H10978

## DESCRIPTIVE REPORT

# Descriptive Report to Accompany Hydrographic Survey H10978

Project OPR-P164-RA

Figure 2. H10978 Junction Surveys.

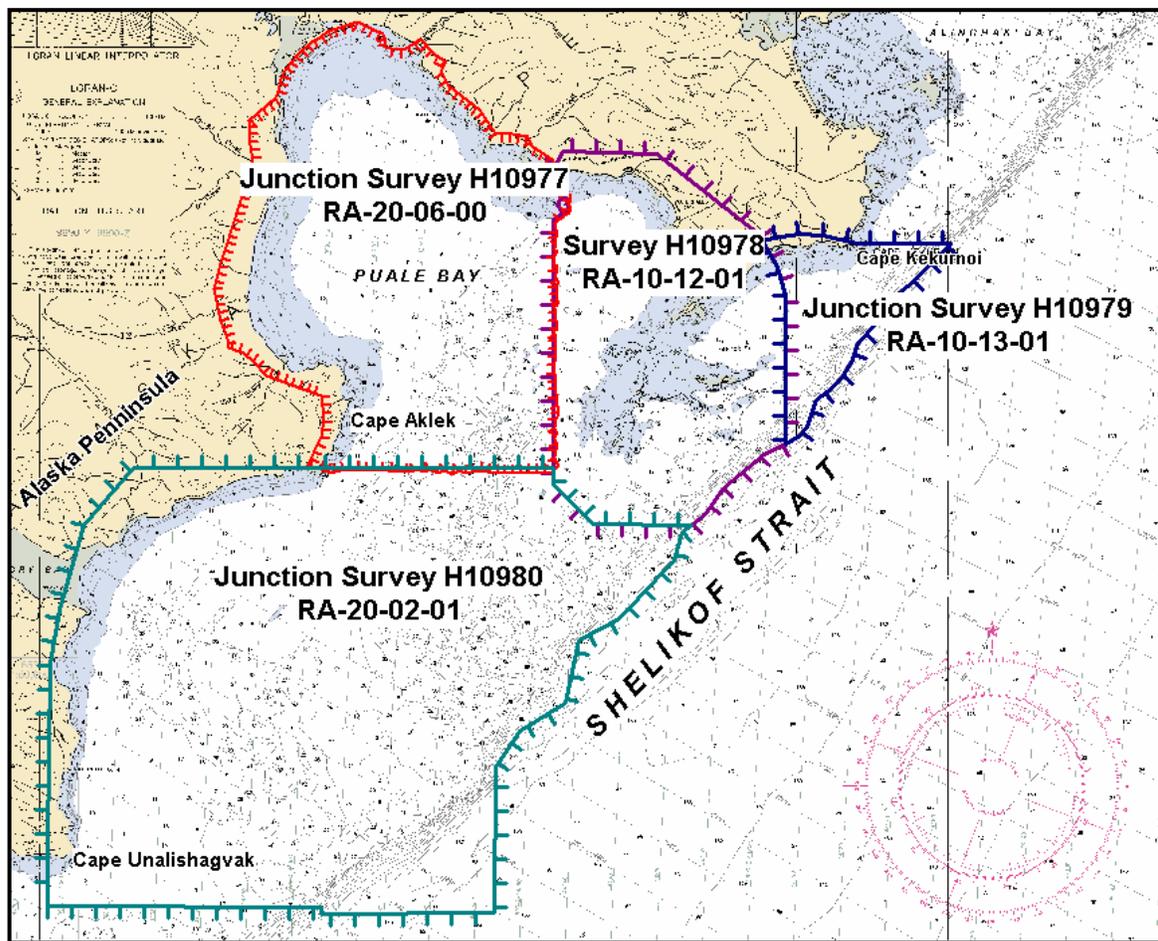
All junction surveys compare well with H10978, with differences of generally one fathom or less.

Final comparisons will be made at the Pacific Hydrographic Branch (PHB).<sup>8</sup>

<sup>8</sup> PHB revision - The junction with H10977 was not formally completed since this survey was processed previously. A comparison of soundings between the surveys shows close agreement, within two fathoms. Some soundings from H10977 been transferred within the common area to better delineate the bottom configuration and to support depth curves common to both surveys. The junction with surveys H-10979 and H10980 are complete.

Figure 3. TS reef not on chart 16575

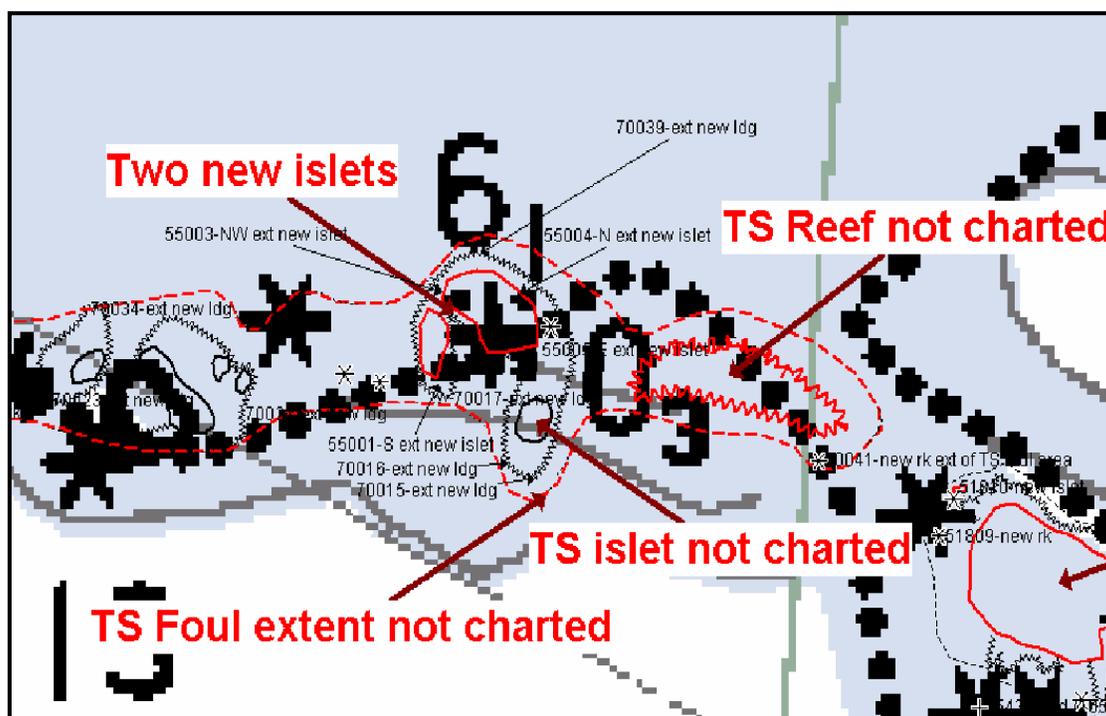
In several areas on chart 16575, the charted shoreline differed greatly from photogrammetric shoreline data from TP-00626 (date of final compilation Nov. 1982). These were both positional discrepancies and what appeared to be omissions in chart compilation. For example, in Figure 3 below, the chart positioned the foul limit at 57°40'47.90"N, 155°23'54.20"W (356,988.4E, 6,395,611.5N) approximately 160 meters north of the TS foul limit. The TS foul limit was verified in the field. The islets depicted on the TP-sheet were not depicted on the chart. In the vicinity of a charted (16575) 0.3-fathom sounding at 57°40'45.09"N, 155°23'49.24"W (357,067.6 E, 6,395,521.7N), the present survey verified the TS reef (in red in Figure 3 below).<sup>53</sup>

<sup>53</sup> PHB revision – Concur, chart area according to the smooth sheet

Figure 4. TS islet not on chart 16575

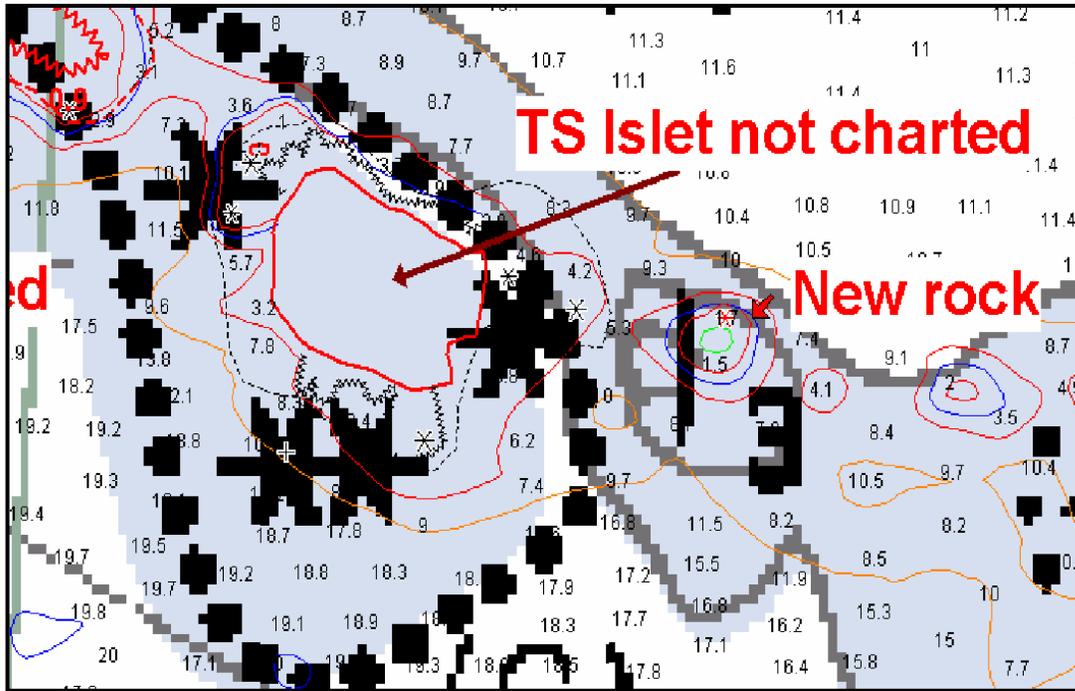
The TS islet at 57°40'38.59"N, 155°23'17.94"W (357,578.7E, 6,395,302.4N) is not charted on chart 16575. The TS islet was verified during the present survey. The Hydrographer recommends charting this islet (refer to figure 4).<sup>54</sup>

<sup>54</sup> PHB revision – Concur, chart islet and surrounding area as shown on the smooth sheet.
